Product Discontinuation Notice

December 17, 2009

No.ICDRY-080040

Solid State Relays (Single-phase) G3PB series

(Relevant model : G3PB-215B/225B/515B/-VD)

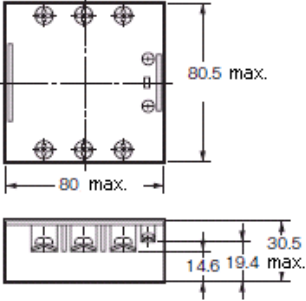
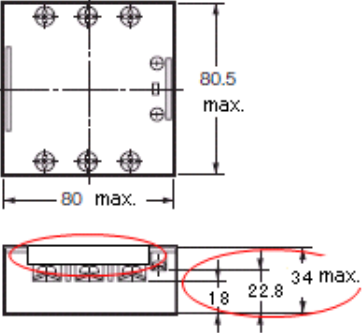
Product discontinuation	G3PE Recommended replacement
	 <p data-bbox="1104 714 1445 787">Note : The change of terminal cover to improve finger protection.</p>

(Relevant model : G3PB-2□□B-2(H)(N)-VD、G3PB-2□□B-3(H)(N)-VD、
G3PB-4□□B-2(H)-VD、G3PB-4□□B-3(H)-VD
G3PB-5□□B-2(H)(N)-VD and G3PB-5□□B-3(H)(N)-VD)

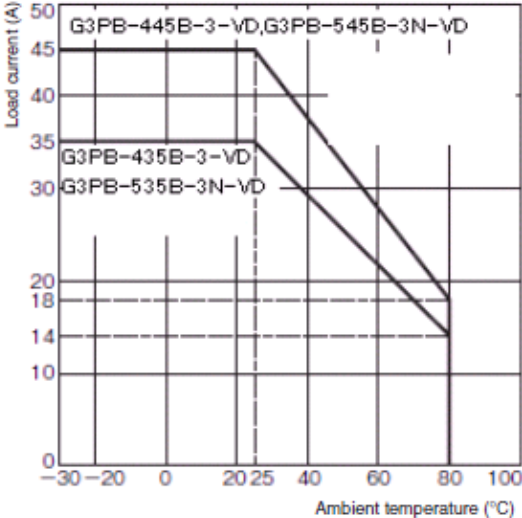
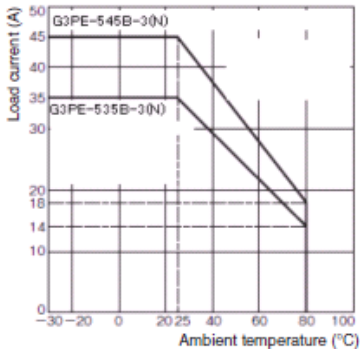
- The shape of G3PE terminal cover is a little different
- The height is 4.5mm taller.(G3PE-□□□B-2(H)(N) and G3PE-□□□B-3(H)(N) models only)
- Last Time Buy Date is subject to factory capacity. Recommend placing Last Time Buy before February 1st, 2010

Product discontinuation	G3PE Recommended replacement
	 <p>Note 1) The change of terminal cover to improve finger protection. 2) Height change</p>
<p>Size of heat-sink is the same</p>
